VALUE ENGINEERING PROPOSAL

PROPOSAL NO: S-10 PAGE NO: 1 OF 5

DESCRIPTION Move Control House Off Lock Wall, Reduce Lock Wall Thickness

PRELIMINARY
SUBJECT TO CHANGE
SCALE: 1/8" = 1'-0"
U.S. ARMY ENGINEER DISTRICT, NEW ORLEANS
CORPS OF ENGINEERS
NEW ORLEANS, LOUISIANA
BAYOU SORREL
LOCK WALL
CONTROL HOUSE

DRAWING NO. 1

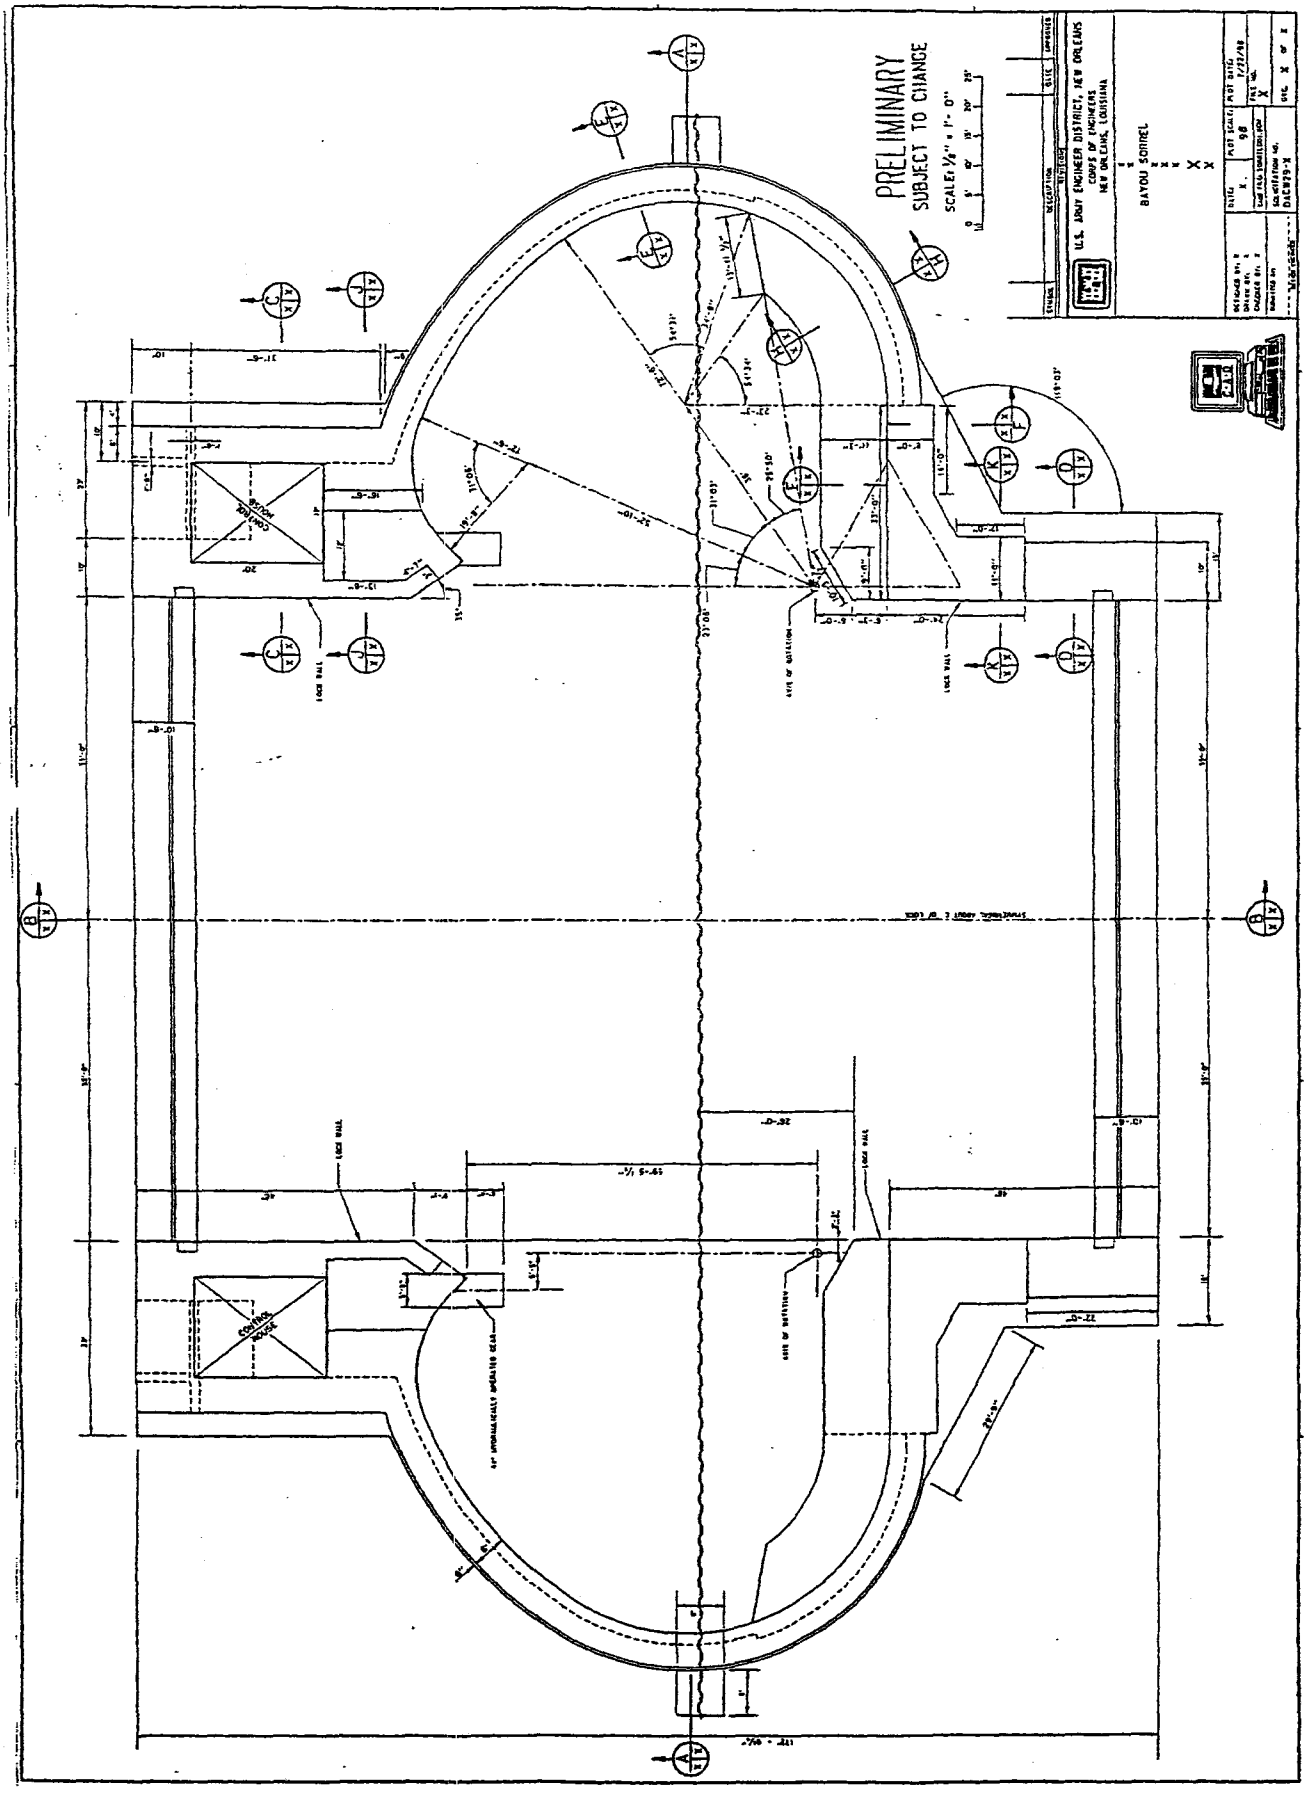
The existing design calls for control houses at each of the four corners of the lock wall 10-ft. from the end of each lock wall. The lock wall thickness at these locations is shown as 23 ft. versus a 10 ft. wall thickness on the other side of the end of the gate bay monolith (reference sections C, J, & D on Drawings Nos. 1, 2, & 3).

Recommend placing the control house either on a cantilevered section or on the esplanade adjacent to the gate bay monolith. This will allow the reduction of the lock wall thickness in this area from 23 ft. to 18 ft.
